# INTERNATIONAL PLUMBING CODE/ INTERNATIONAL PRIVATE SEWAGE DISPOSAL CODE

**P4-06/07**  
**103.2, 103.3, 103.4**

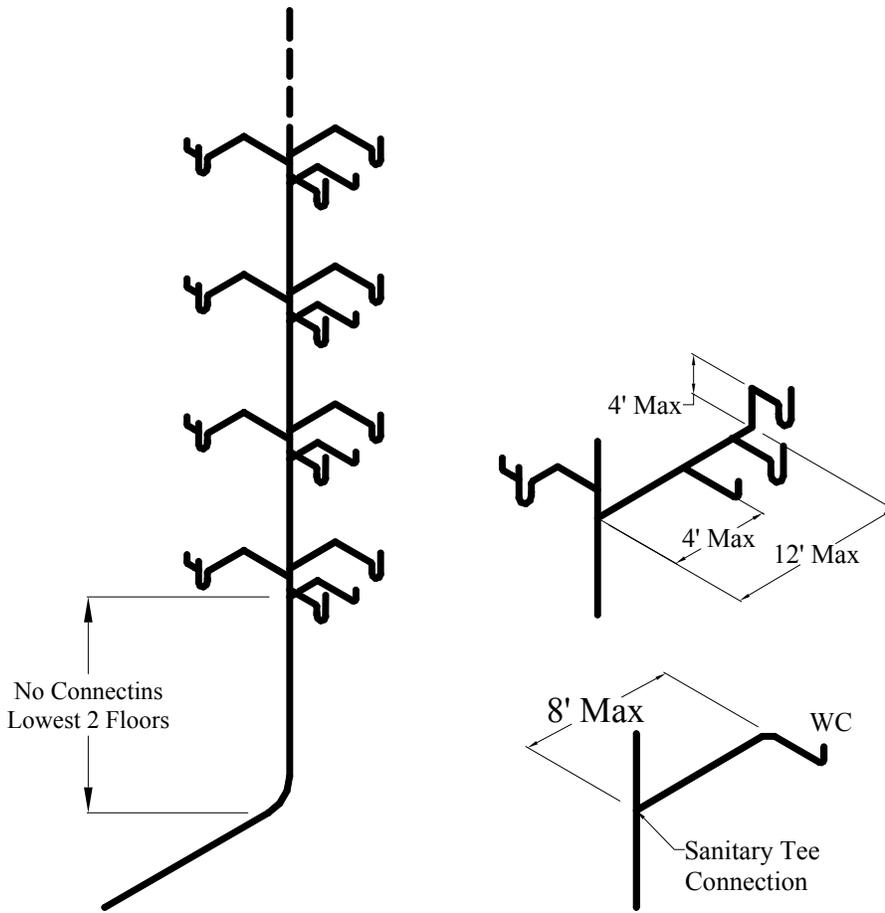
Note that the trap sizes in the one pipe vent system are comparable to those in Chapter 7 and are not oversized. What is oversized is any vertical drop that forms an "S" trap.

The following is a comparison of the DFU stack loading allowed by the various model plumbing codes for conventionally vented drainage systems, compared to a single stack vent system less than 75 feet in height.

The Philadelphia Plumbing Code allows 75 DFU and six (6) water closets on a 3" stack, which is comparable to a conventionally vented drainage system. This proposal limits a 3" stack to 24 DFU and two (2) water closets, which is comparable to an average dwelling unit.

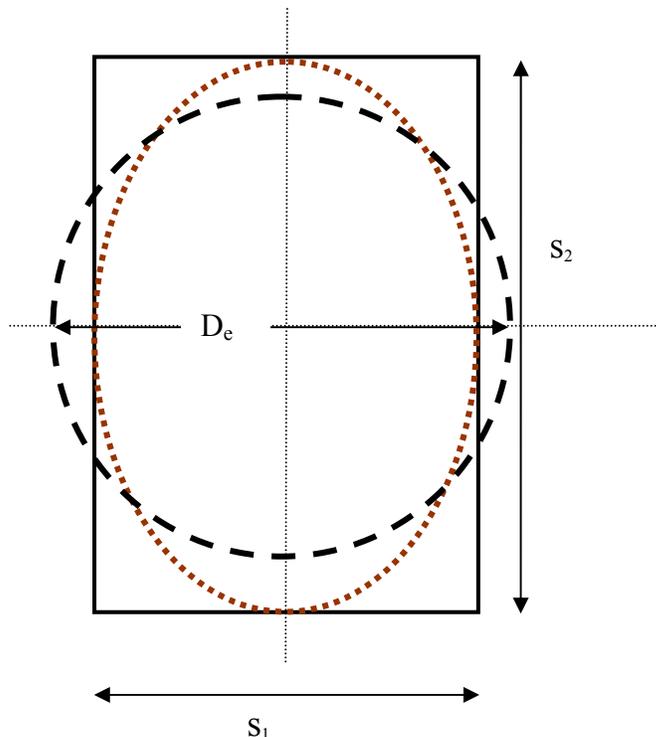
Table 1106.2 of the 2006 International Plumbing Code is based on empirical investigations of circular leaders. The table provides, for the purposes of design, the relationship between roof area and rainfall rates and the required leader diameter. The Metal Building Manufacturers Association has performed an engineering study to determine a more reasonable rationale for determining the flow capacity of rectangular vertical leaders. The following is a geometrical argument, which provides a reasonable design of rectangular leaders. Applied in the practical range of rectangular leader cross-section geometry, this method will be conservative, i.e. flow in the rectangular leader will be more than the equivalent circular leader. A simplistic way of looking at this in terms of equivalent flow capacity is to imagine you are deforming a circular leader into an ellipse and fitting it inside the rectangular leader.

The following is the algebraic derivation of the equivalent circular diameter,  $D_e$ . The rectangular leader, inscribed ellipse, and the "equivalent" circular diameter are shown in the attached figure. The assumptions applied are: (1) The inscribed elliptical area provides a conservative estimate of flow through the rectangular area, and (2) The equivalent circle is based on setting the area of the ellipse equal to the area of the equivalent circle. For the inscribed ellipse,
